**REDLINE REVISION NO. 5**  
 MD 175 AT DISNEY ROAD; REVISED POLE LOCATIONS IN THE NW QUADRANT  
 [Signature] 1/21/2013  
 FIELD TEAM LEADER APPROVAL DATE

**SHA** STATE OF MARYLAND  
 DEPARTMENT OF TRANSPORTATION  
 STATE HIGHWAY ADMINISTRATION  
 OFFICE OF TRAFFIC & SAFETY  
 TRAFFIC ENGINEERING DESIGN DIVISION  
 MD 175 (ANNAPOLIS ROAD) AT  
 26TH STREET/DISNEY ROAD  
 FORT MEADE, MD

ULTIMATE TRAFFIC SIGNAL PLAN		
SCALE 1" = 20'	ADVERTISED DATE 4/26/1984	CONTRACT NO. AA 797-501-585
DESIGNED BY MICKEY CORNELIUS	COUNTY ANNE ARUNDEL	
DRAWN BY MICKEY CORNELIUS	LOGMILE 02017507.10	
CHECKED BY	TMS NO.	
F.A.P. NO. SEE TITLE SHEET	TOD NO.	
TS NO. 1959D	DRAWING SG - 03 OF 5	SHEET NO. 149 OF 195

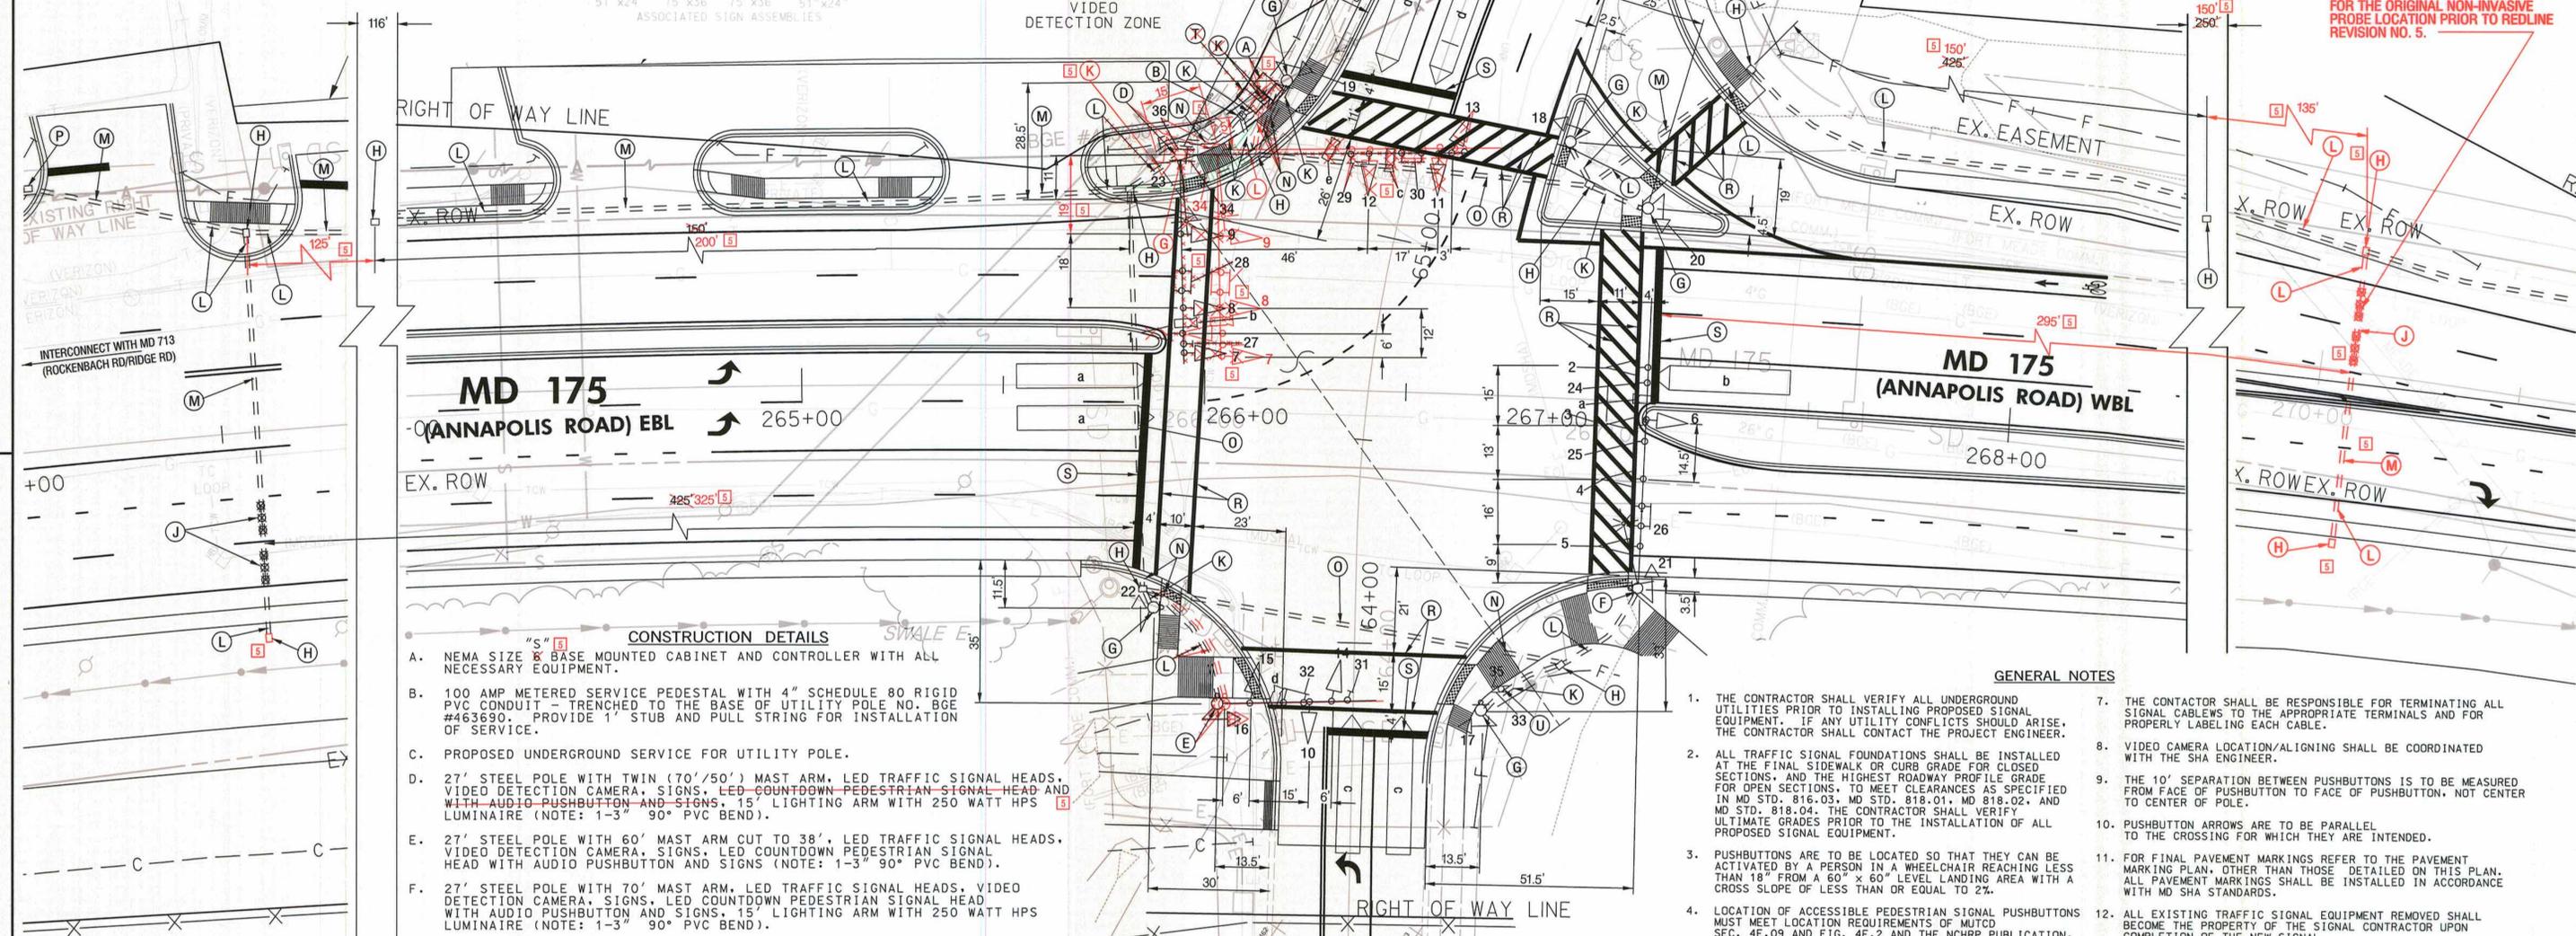
NOTE: SEE INTERCONNECT DRAWING SG-05 FOR THE ORIGINAL NON-INVASIVE PROBE LOCATION PRIOR TO REDLINE REVISION NO. 5.

APPROVALS	REVISIONS
TEAM LEADER	01 REDLINE NO. 5 1/2013
ASST. DIV. CHIEF	02 INSTALL NEW PEDESTAL POLE IN THE NW QUADRANT, RELOCATE SIGNAL POLE ENB
DIVISION CHIEF	03 BRAC RECONSTRUCT TRAFFIC SIGNAL SHA #: AA5805370 TMS NO. J-969 10/2010
OFFICE DIRECTOR	04 ENB
	05 1/24/97 ASBULL SHA #: BW860802512
	06 RRZ
